**From:** Roland Benke  
**Sent:** Thursday, March 23, 2006 10:47 AM  
**To:** Brittain Hill; Donald Hooper; Keith Compton  
**Subject:** accelerated erosion in ASHREMOB  
**Attachments:** draft response for TPA code comments in Section E (325 KB); draft response for TPA code comments in Section E (additional... (178 KB); Final summary of Redistribution meeting, Sept 29, 2005 (18.0 KB)

**From:** Roland Benke  
**Sent:** Sunday, September 18, 2005 10:07 PM  
**To:** Richard Codell  
**Cc:** Bret Leslie; Christopher Grossman; Donald Hooper; James Winterle  
**Subject:** draft response for TPA code comments in Section E  
**Attachments:** TPA501\_CommentResolution\_SectionE.wpd; Figure\_E-1.doc

<b>E. Redistribution and Mass Loading Associated with the Igneous Extrusive Scenario</b>		
<b>Proposed NRC Lead: Dick Codell</b>		
<i>Comment</i>	<i>Proposed Response</i>	<i>Description of Proposed Code Modifications</i>

Note to: Attendees, volcanic redistribution meeting, Sept 29, 2005  
From: Richard Codell  
Subject: Summary of discussions

Figure E-1. Satellite Image of Amargosa Valley.

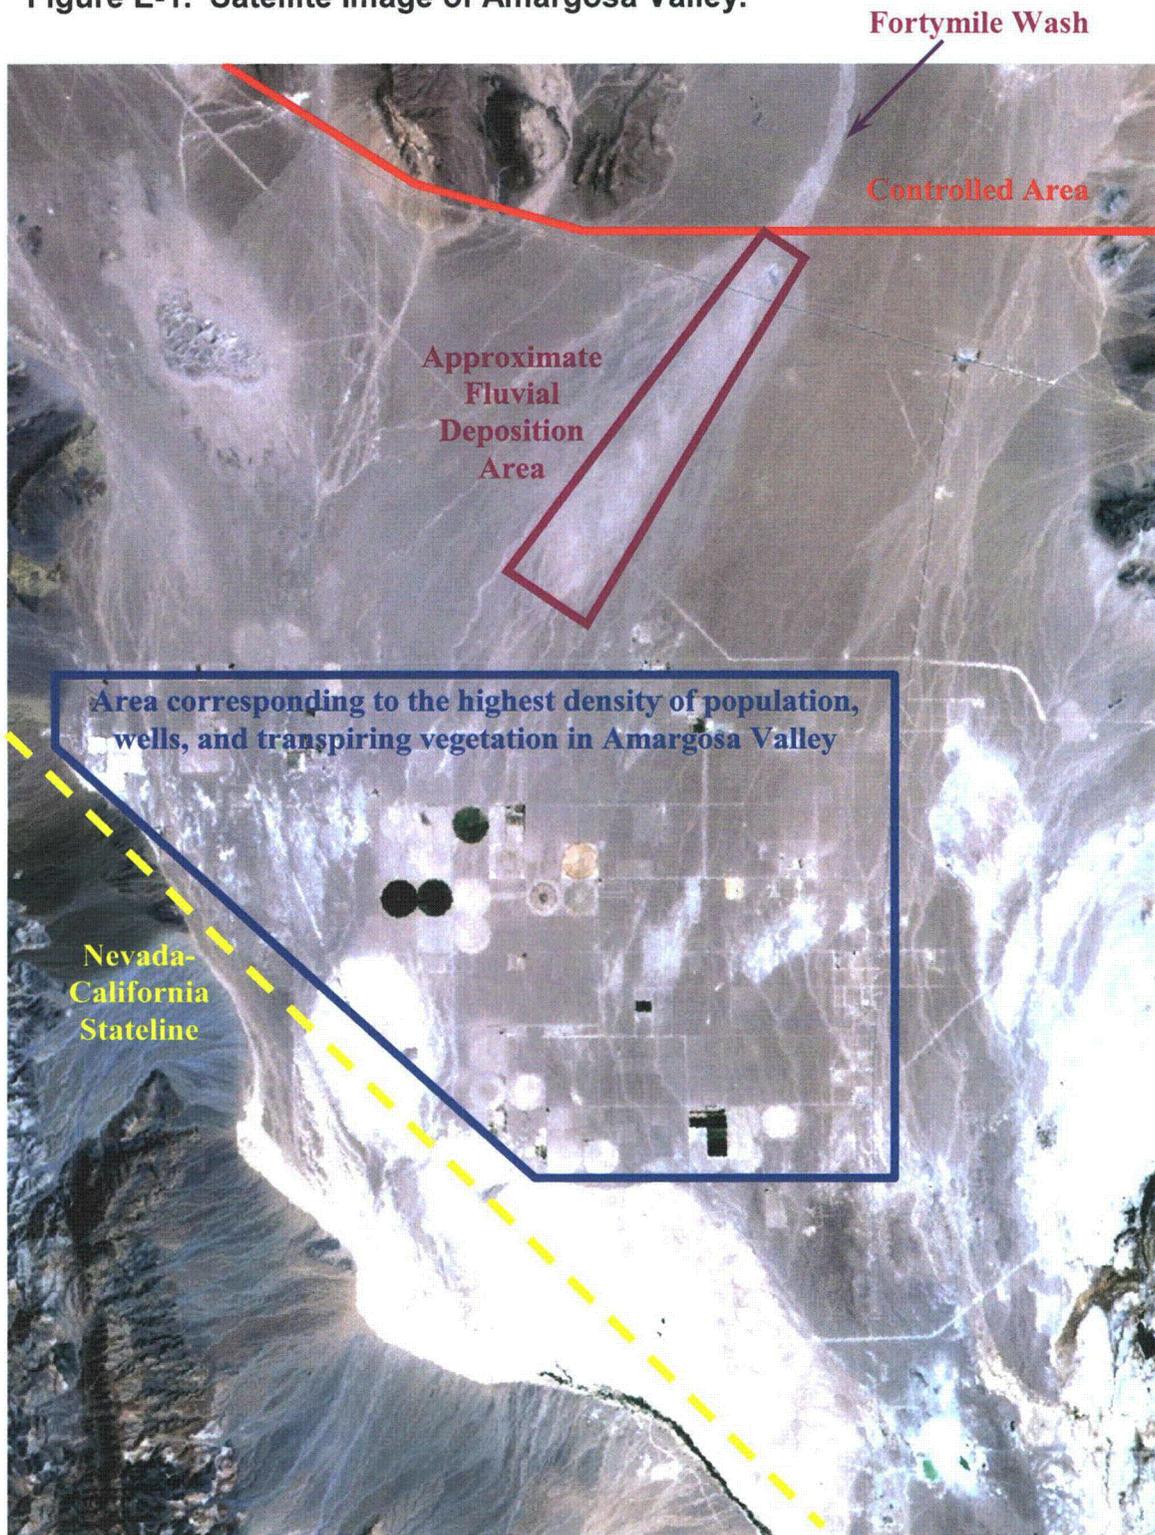
1. Abstraction should be consistent with 10 CFR 63 concept of the reasonably maximally exposed individual and not presume the location of the individual in, or directly adjacent to, the depositional fan of Forty Mile Wash.	The area for the receptor location will be based on the highest density of population, wells, and transpiring vegetation in Amargosa Valley (see Figure_ E-1.doc).	<p>1. Modify the TEPHRA code algorithm to compute the average initial tephra-fall deposit (mass ash or HLW per unit area) for the nodes located within the receptor area (see Figure_ E-1.doc).</p> <p>2. Recompute the TEPHRA look-up table.</p> <p>3. For consistency, modify ASHPLUME and ASHPLUMO to compute an average initial tephra-fall deposit for the same receptor area.</p>

# Cave A: "Thick" Fluvial Deposits

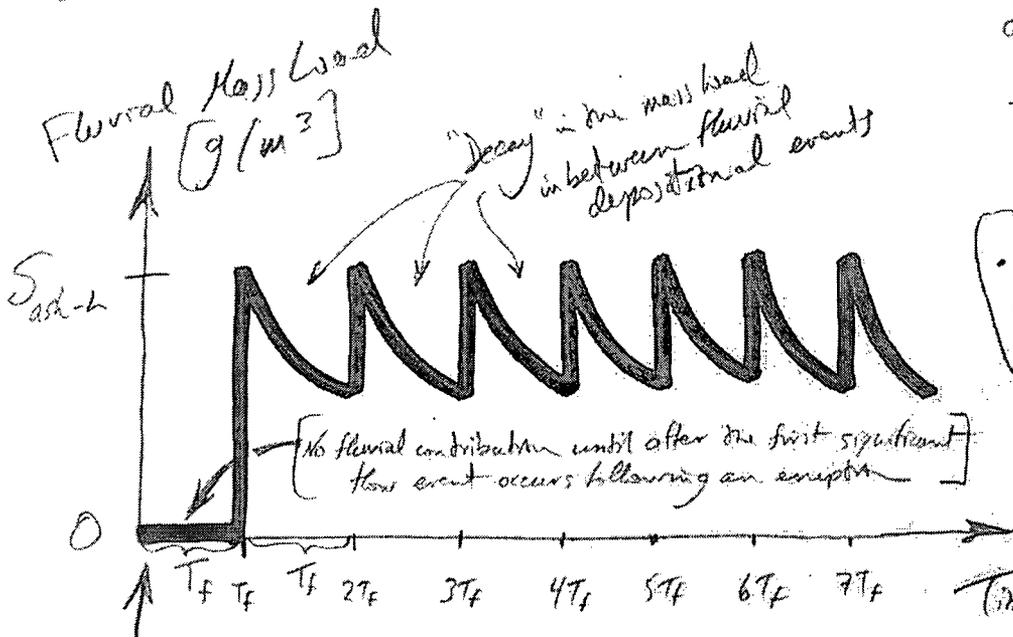
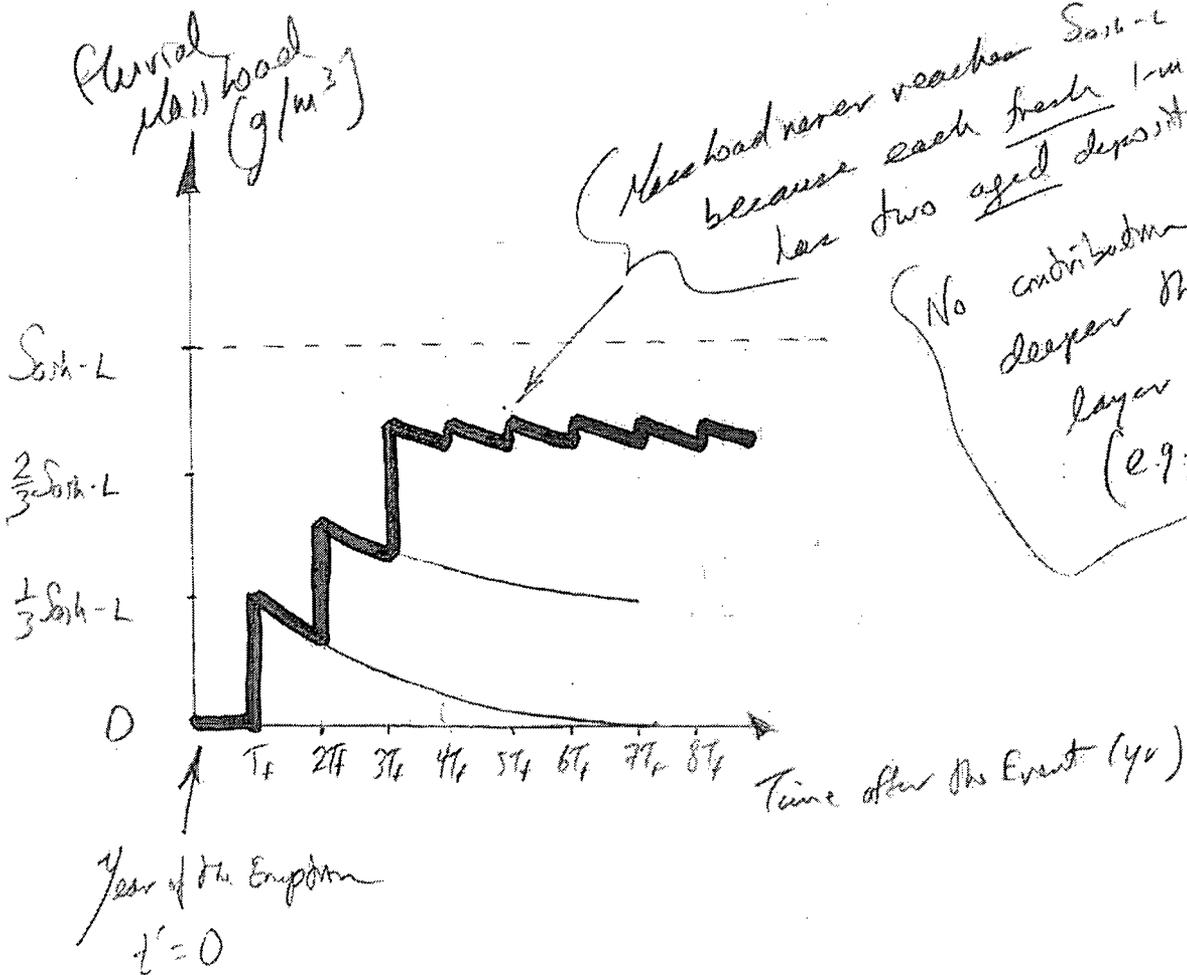
<p>4. Address the need for a strengthened technical basis or revised conceptual model to address for the lack of decay related to fluvial remobilization.</p>	<p>Reduction in mass load for the fluvial source region will be included for time periods in between significant flow and depositional events.</p>	<p>1. Modify ASHREMOB module to calculate a time-dependent fluvial mass load fraction accounting for (i) exponential decay of mass load between significant flow events using the <code>RateOfReductionOfMassLoadingFactor [1/yr]</code> parameter, (ii) the thickness of fresh fluvial deposits covering older fluvial deposits, and (iii) dilution from resuspending deposits, thinner than the resuspendible layer depth, which are overlying aged deposits or clean soil. Illustrative examples are provided for two cases: (a) "thick" fluvial deposits, see <code>CaseA_ThickDeposits.jpg</code>, and (b) "thin" fluvial deposits, see <code>CaseB_ThinDeposits.jpg</code>.</p> <p>2. Modify ASHREMOB module to calculate the time-weighted average of mass load fraction between the present and next TPA time steps. Multiply the mass load for ash under light disturbance parameter value by this average value to determine the mass load used for the fluvial source region at the present TPA time step.</p>

Fluvial Redistribution yields a deposit with a thickness greater than or equal to the resuspendible layer depth (3mm)

Fluvial redistribution yields a deposit with a thickness less than one resuspendible layer depth (3 mm)

Example shows the change in airborne mass load assuming each significant flow event yields a 1-mm fluvial deposit
